# Inspection of Automatic Sprinkler System

AW4 Molan Pino East London Industrial Development Zone

UNC8473

09.05.2024 08:00 SAST

Photo 2

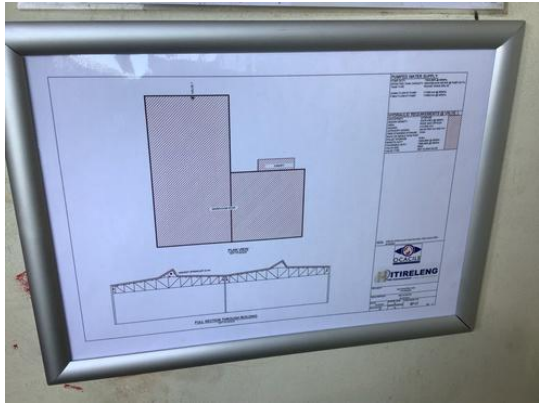
South side of building
